Derby Diocesan Association of Church Bellringers	Report DDACB 11/05
Inspection of Bell Installation at the Church of All Saints Wingerworth	Issue Date 24/10/05

FIGURE 4 PINGING ROOM

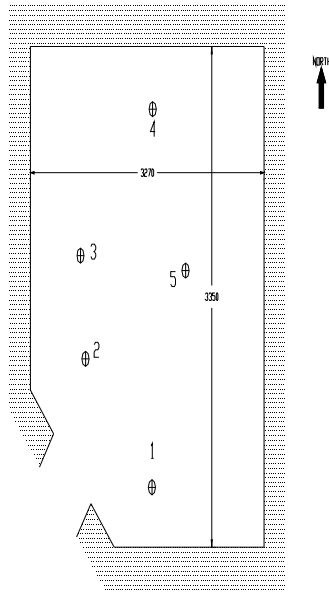
Reached by a spiral staircase (24 steps) the room is almost square in section allowing for the built in spiral staircase. The area is carpeted and illuminated by a single fluorescent light. The height of the wooden ceiling is quite low (2.97m.) and the noise of the bells in the chamber, although not measured, is reported to be louder than the ideal. There also appeared to be signs of water

ingress at ceiling level. The ringing circle is awkward (see Figure 4) and ringing bells 2 & 3 could be a problem for inexperienced ringers.

FIGURE 5 GROUND FLOOR Existing rope circle transposed to ground floor

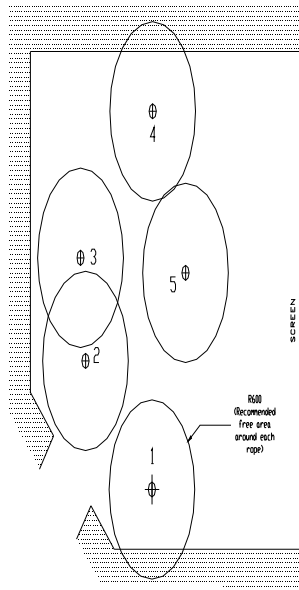
Figure 5 shows the ringing circle if there was no change to the pulley positions or 'draws' on Bells 2 & 4 and the ropes were extended down to ground floor level.

FIGURE 7 POSSIBLE IMPROVEMENTS TO RINGING CIRCLE

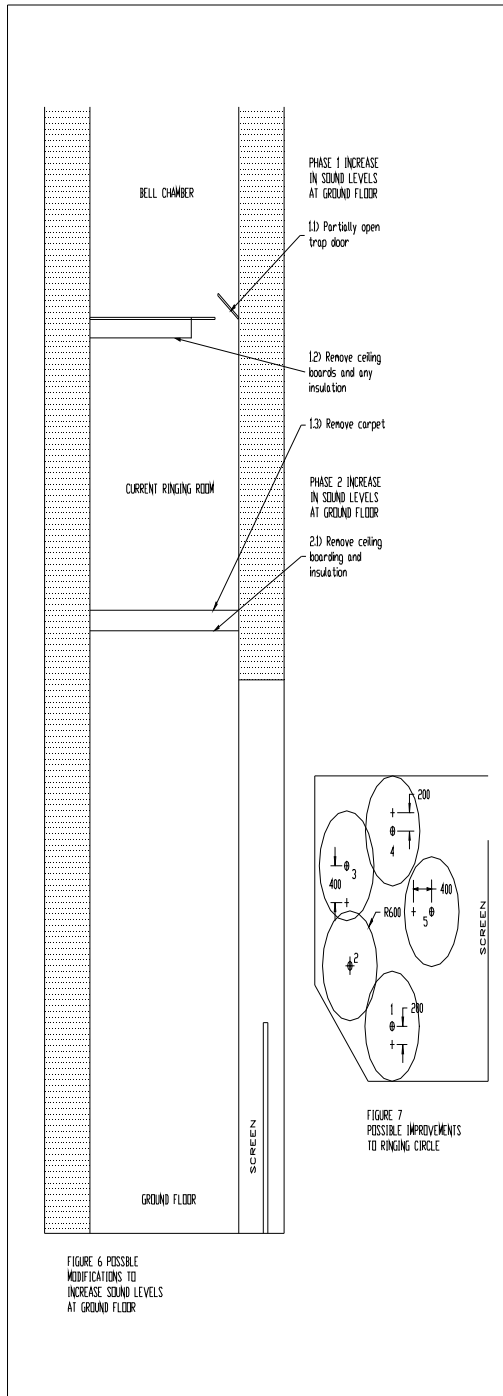
Figure 6 shows the improvements to the ringing circle that could be made by altering the pulley and 'draw' positions.

- 10.7 Alterations to the ringing circle mentioned by John McCartney in his letter of 19th. September should be carried out.
Figure 7 shows the rope circle that could be obtained assuming that the beams in the present ringing room floor do not interfere with any of the new location holes required for the ropes to pass through. Serious thought should be given to fitting rope guides under the existing ringing room floor as the lateral movement as mentioned by John McCartney in his letter will increase.
- 10.8 Due to the extra distance from the ringing position to the wheels it is thought that the existing ropes will not be long enough. There are three options
 1. Purchase new ropes.
 2. Make enquiries into obtaining second hand ropes.
 3. Splice an extra length onto the existing ropes.
